**DIRECT TESTIMONY OF  
BRENDAN KIRBY  
ON BEHALF OF  
SOUTH CAROLINA COASTAL CONSERVATION LEAGUE AND  
SOUTHERN ALLIANCE FOR CLEAN ENERGY  
DOCKET NO. 2019-2-E**

## Analysis of SCE&G's Proposed Variable Integration Charge

Brendan Kirby, P.E – March 2019

Figure 1 Potential reserve shortfall events by year for the 1050 MW SC2 solar case.

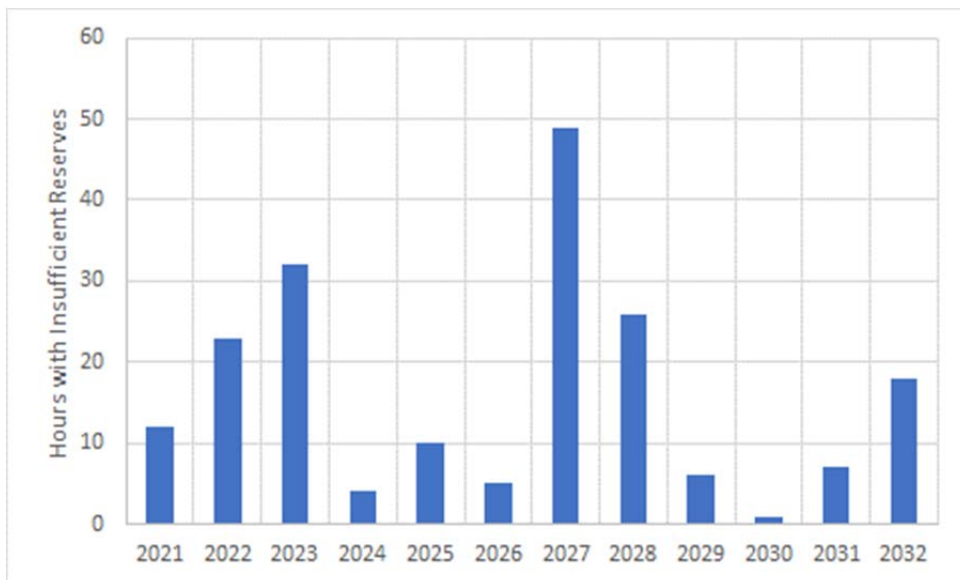
The 193 reserve shortfall hours do not represent times when the simulated power system would have less generation than load. Rather, they instead represent hours when reserves would be insufficient *if* solar generation happened to experience the maximum decline during that hour. Figure 1 shows the distribution of reserve shortfall events by year.

Figure 2 There are very few large reserve shortage events for the SC2 1050 MW solar case.

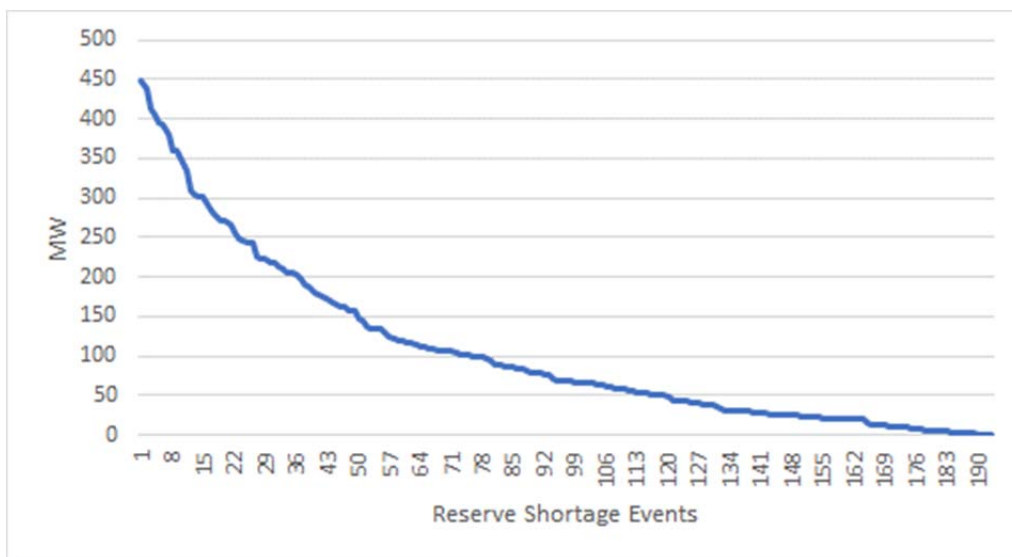
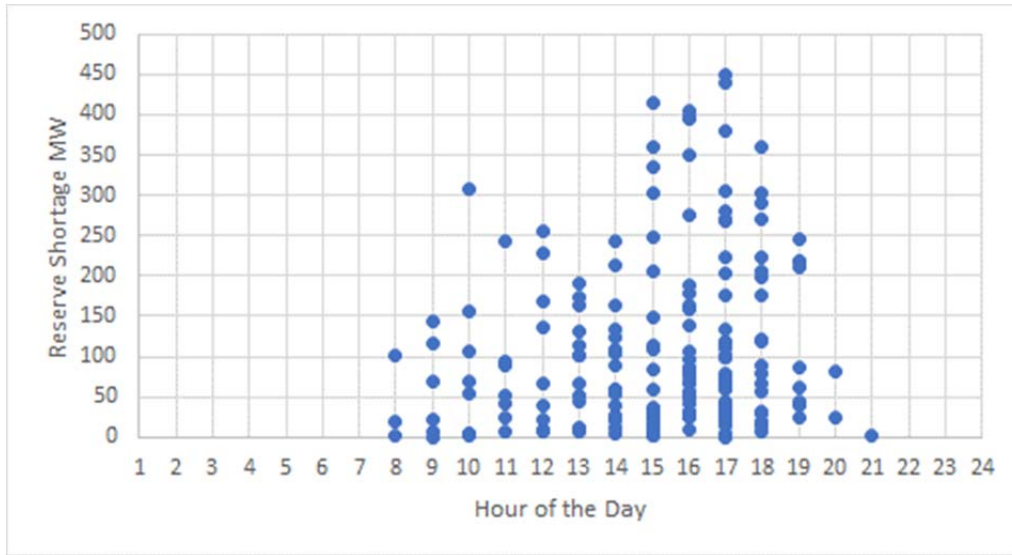
Figure 2 shows the size distribution of the potential reserve shortfalls.

The number of reserve shortage events and their size are important because they show that solar reserve shortage events are like mild conventional generator contingencies. They are “mild” because they do not require very fast spinning-reserve response, in fact they do not even require the 10-minute response of non-spinning contingency reserves. The very nature of cloud-driven solar declines results in ramping down over many minutes, not instantaneous tripping.

Figure 4 Fairfield was pumping for 2075 hours in 2030<sup>16</sup>

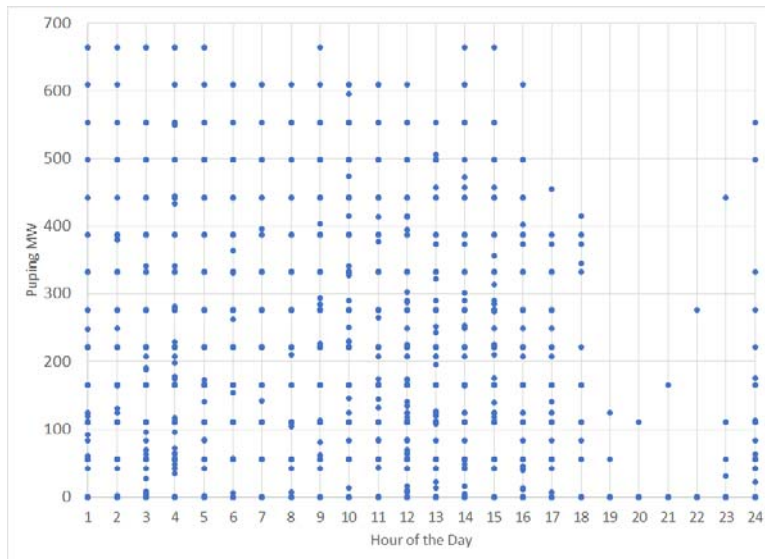
Fairfield could supply additional reserves while pumping. As noted above, SCE&G states that Fairfield can switch from pumping to generating in less than 15 minutes. The pumping load should be available as a reserve, in addition to the 576 MW of generation capability. Fairfield is modeled as pumping during 2075 hours (24% of the time) in the 2030 SC2 PROMOD simulation, with an average 241 MW and maximum 664 MW pumping load. The 2075 hours are already included in the 7736 hours with adequate reservoir capacity but the 241 MW average, 664 MW maximum of reserves capacity is additional. Figure 4 shows that pumping is expected to occur throughout the day, not just at night. These added reserves can be very effective for solar integration.

The hours of Fairfield pumping shown in figure 4 clearly overlap the hours of potential reserve shortfalls shown in Figure 3.

**Recommendation:** The Commission should direct SCE&G to count Fairfield generation as available reserve for integrating solar generation whenever Fairfield is off-line or pumping and there is sufficient storage available. In addition, the Fairfield pumping load should be counted as available reserves for integrating solar generation.
